DESCRIPTION:	—	TARRIF# 7604.21.00.00	PROPOSAL# 40915-3
	DATE	SYM	REVISION

ARCHITECTURAL FENCE & RAILINGS		UNSPECIFIED WALL THICKNESS	SIGNED: _____ DATE: _____
		③ 0.050(1.27) ±0.010(0.25) H	
EST. AREA 0.378 IN ² 244 MM ²	OUT PER. 7.146 IN 182 MM		
EST. WT. 0.454 LBS/FT. 0.675 KG/M	FACTOR 33		
EST. PER. 14.893 IN 378 MM	C.C.D. 3.041 IN 77 MM		
DWN BY Kim	ALLOY 6063-T5	SCALE 2:1	DATE 15,03,2024
BREAK ALL CORNERS .016"R (0.41 mm)R UNLESS OTHERWISE NOTED.			STANDARD ALUMINUM ASSOCIATION TOLERANCES TO APPLY UNLESS OTHERWISE SPECIFIED

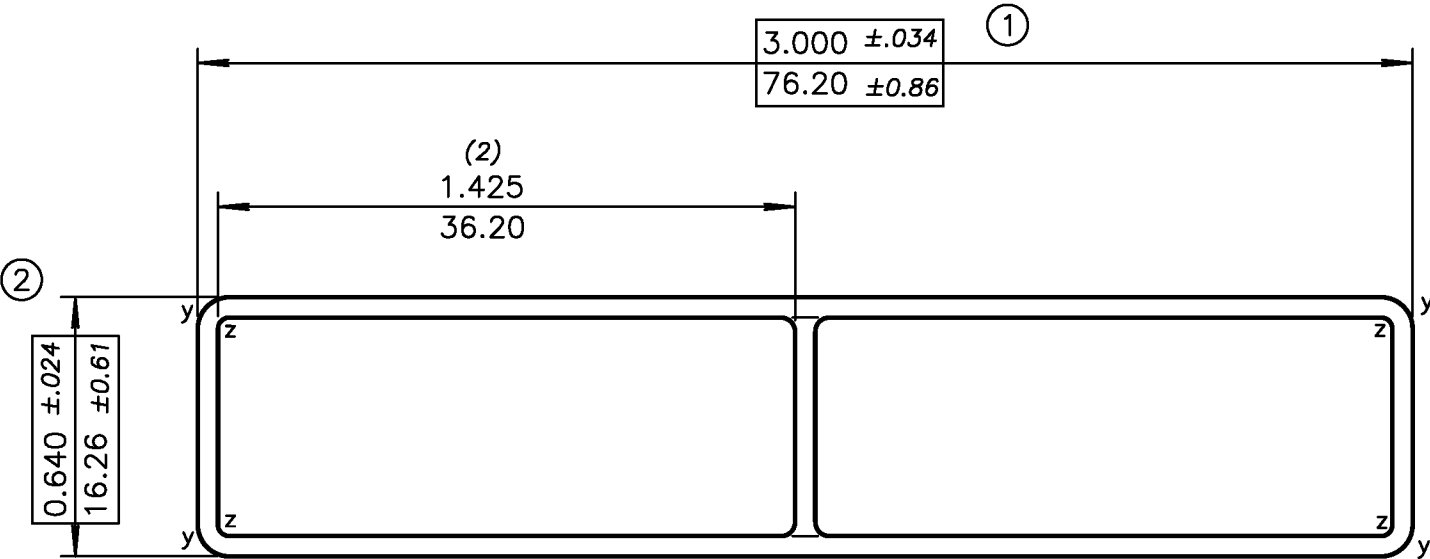
NO I.D. MARKS DUE TO THIN WALL.

PLEASE ALLOW FLATNESS TOLERANCE
0.006" PER 1.000" OF WIDTH
